Livability 22202 Route 1 Working Group

Concept Planning Study Area

What is our conclusion about VDOT's Phase 1?

Option 1 AM Speed Comparison – Sensitivity Analysis

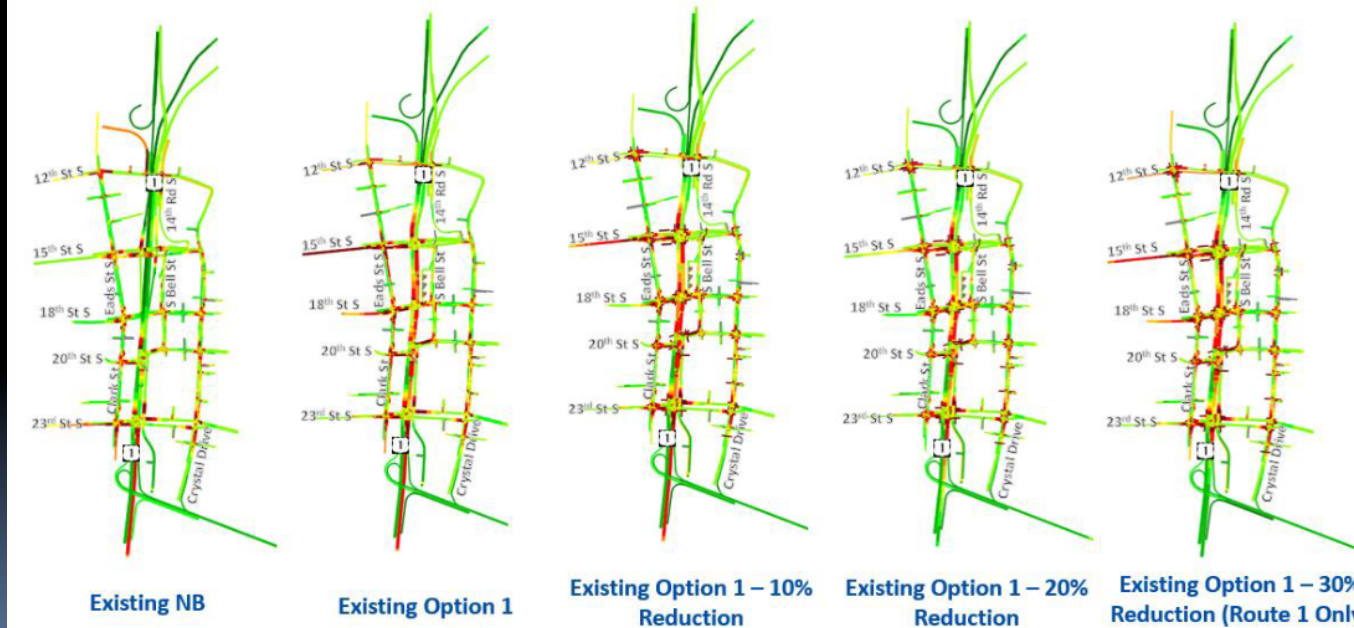
3 Problems with at-grade Route 1 at 18th

#1-More Traffic Congestion on Route 1

Table 7-6 Change in MWCOG Model Daily Volume on Select Study Area Links, 2025 Model Year

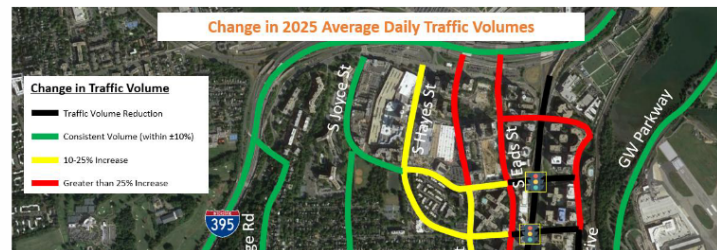
#2 More Traffic on our local streets

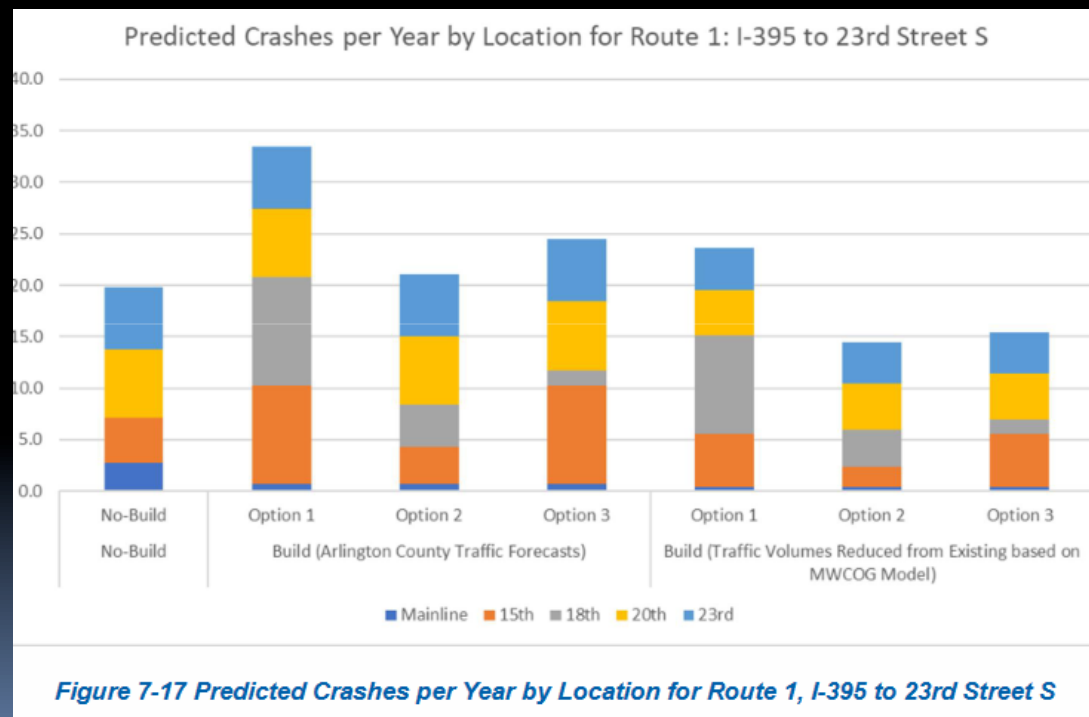
#3 Higher risk of crossing Route 1
